WATER QUALITY MEMORANDUM

Utah Coal Regulatory Program

RE: 2010 2nd Quarter Water Monitoring, Consolidation Coal Company, Hidden Valley Mine, C/015/0007-WQ10-2, Task ID #3564

TDS vs. Time

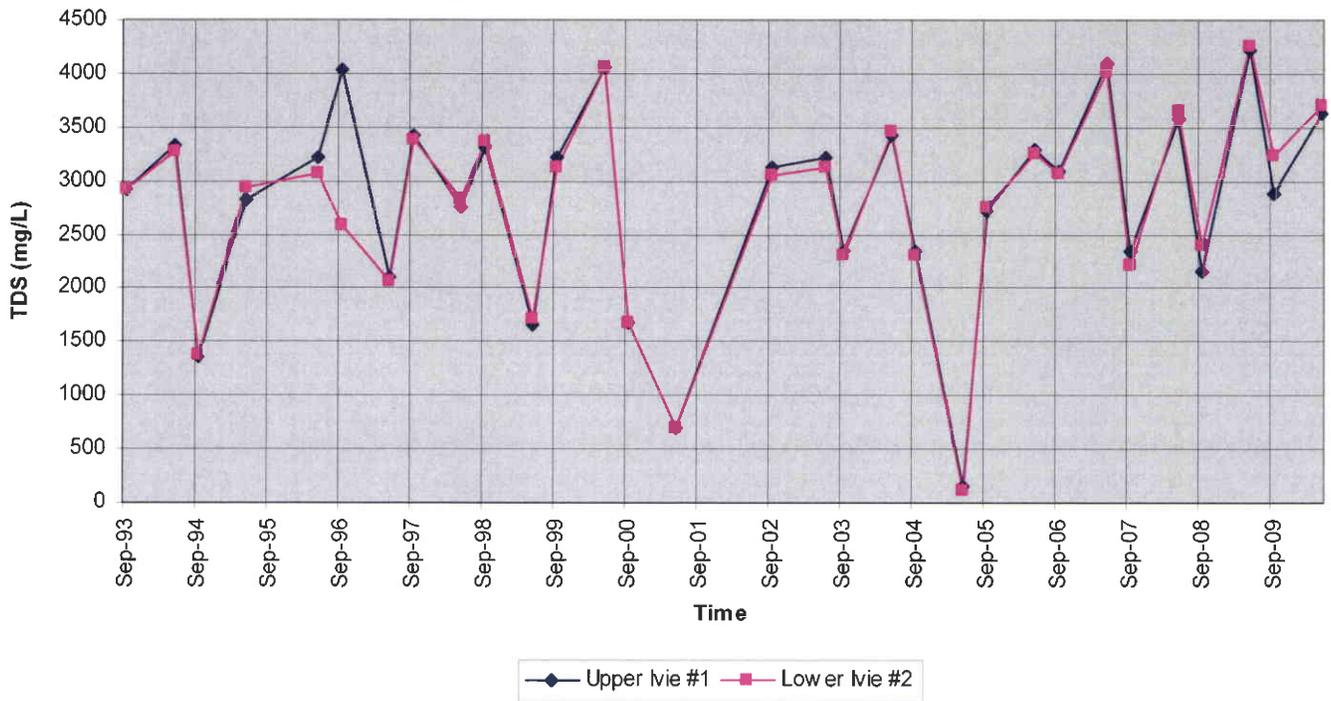
Values obtained for pH and TDS for this quarter follow historic seasonal trends (See Attached Figures).

A TDS value of 2,600 mg/L is the site-specific standard as established by UAC R317-2, *Standards for Waters of the State*. The TDS values obtained for both Upper Ivie #1 and Lower Ivie #2 for this quarter were 3,622 and 3,693 mg/L respectively.

Based upon previous sampling data, seasonal TDS trends for the Ivie Creek drainage produce higher values during the 2nd quarter (spring/early summer) as opposed to the 3rd quarter (late summer/ fall). As a result of snowmelt, irrigation return flow and increased precipitation during the spring/early summer months, it would appear that the ephemeral drainages that contribute flow to Ivie Creek experience a flushing event that produces higher TDS values.

sediments may be deposited in these ephemeral drainages by wind erosion. Following the spring 'flushing event', the data clearly shows that TDS values drop significantly between the 2nd and 3rd quarter of the year as the sediment has been washed down gradient.

The Ivie Creek drainage has consistently produced TDS levels well above the 2,600-mg/L standard discussed above. However, as the site has been reclaimed, it's unlikely that the elevated TDS levels are a result of coal mining related activity. Recent field inspections by Division staff have documented the site as being in stable condition with no signs of excessive erosion or gullies.
